UNITED STATES
NUCLEAR REGULATORY COMMISSION
WASHINGTON, D. C. 20555

BROWNS FERRY NUCLEAR PLANT, UNIT NO. 1

AMENDMENT TO FACILITY OPERATING LICENSE

SAFETY EVALUATION BY THE OFFICE OF NUCLEAR REACTOR REGULATION
SUPPORTING AMENDMENT NO. 44 TO FACILITY OPERATING LICENSE NO. DPR-33
AMENDMENT NO. 40 TO FACILITY OPERATING LICENSE NO. DPR-52
AMENDMENT NO. 17 TO FACILITY OPERATING LICENSE NO. DPR-68
TENNESSEE VALLEY AUTHORITY
BROWNS FERRY NUCLEAR PLANT, UNITS NOS. 1, 2 AND 3
DOCKET NOS. 50-259, 50-260, AND 50-296

Figure 4.2-1

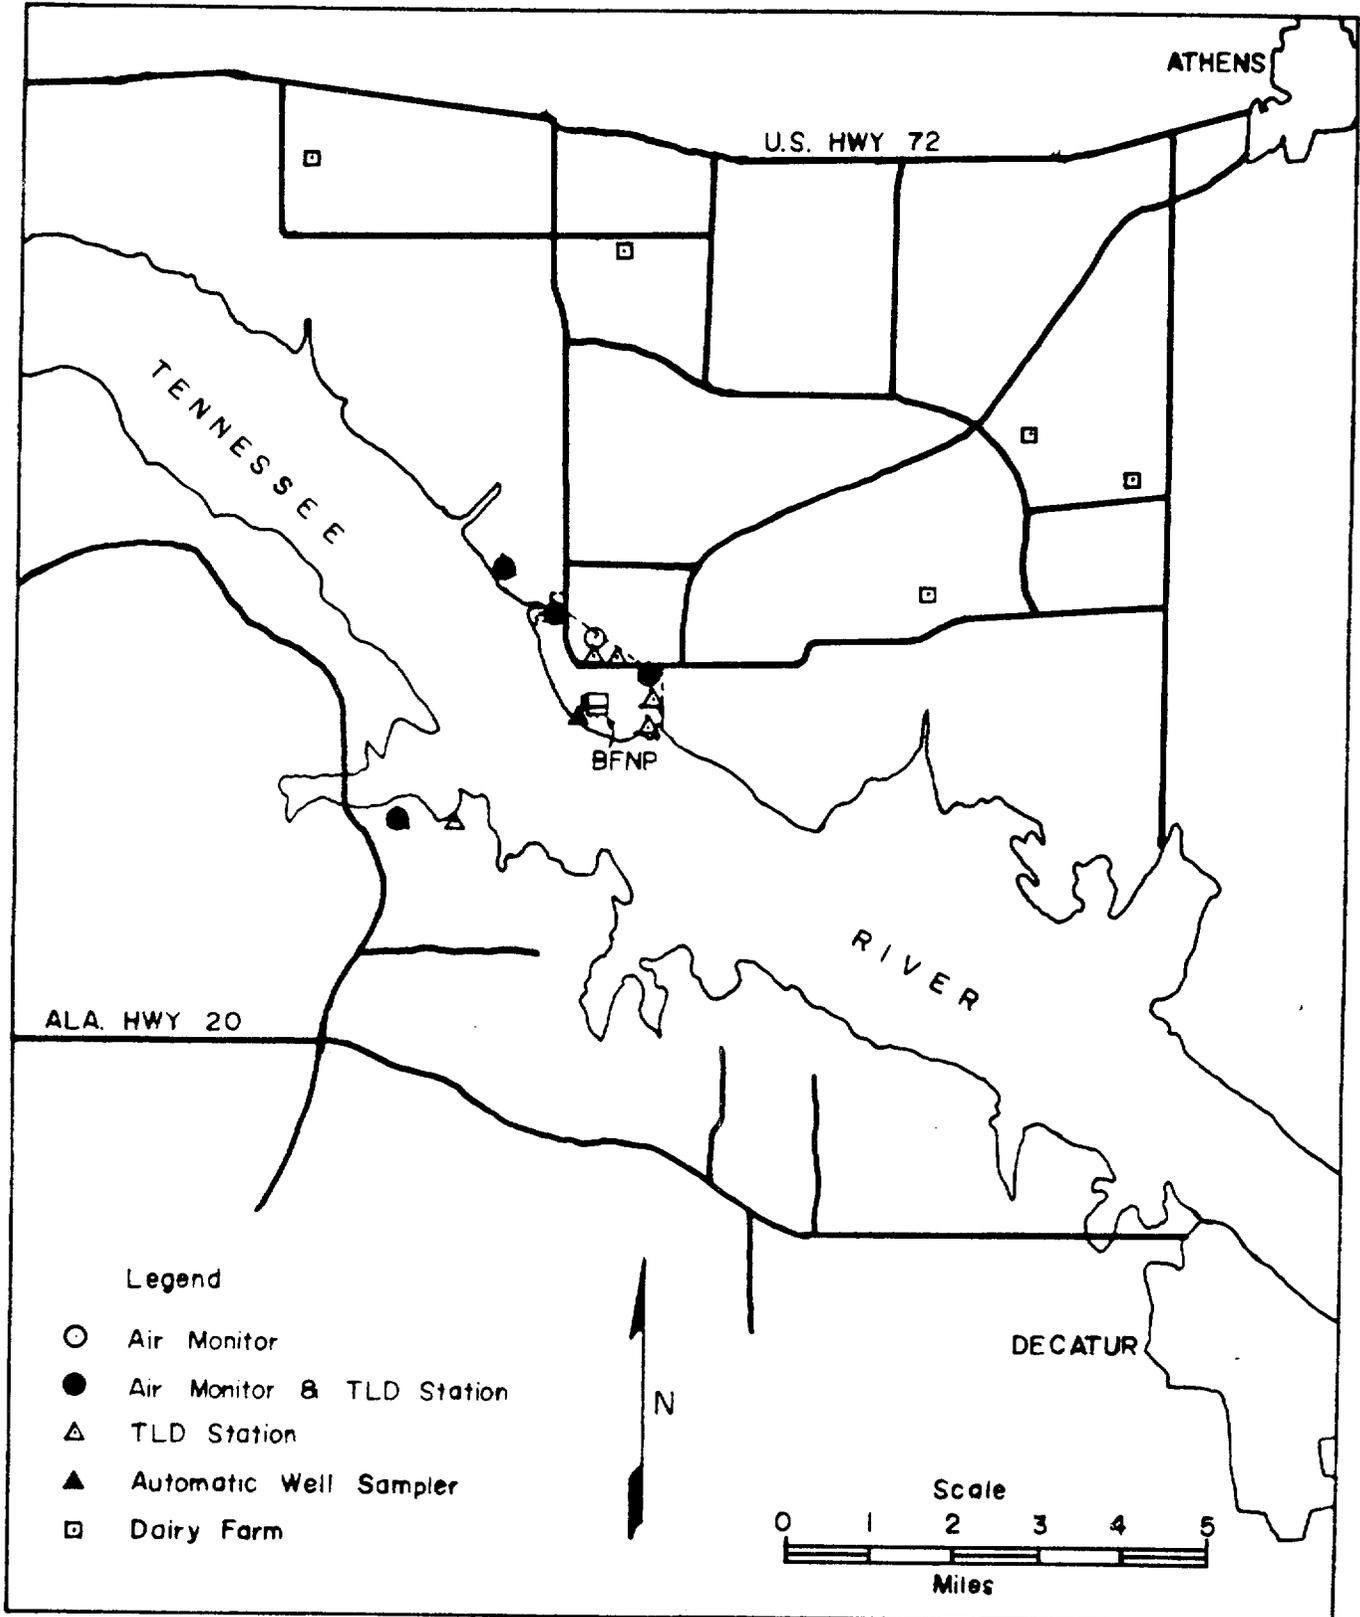
As part of the environmental radiological monitoring program at the Browns Ferry Nuclear Plant, TVA collects and analyzes a number of samples. The Browns Ferry Nuclear Plant Environmental Technical Specifications state that "milk shall be collected....from at least four farms in the vicinity of the plant..." and that"...any location from which milk can no longer be obtained may be dropped from the surveillance program. The NRC shall be notified in writing that milk-producing animals are no longer present at that location. An additional milk sampling location will then be added to the program..." (Section 4.2.3.b).

As of May 15, 1978, milk is no longer available from the dairy farm located approximately four miles north of Browns Ferry Nuclear Plant. The milk producing animals have been sold and removed from the farm. A dairy farm located approximately five miles north of the plant has been added to the monitoring program.

We have reviewed the meteorological data and deposition factors for the Browns Ferry plant and conclude that the new sample location is acceptable.
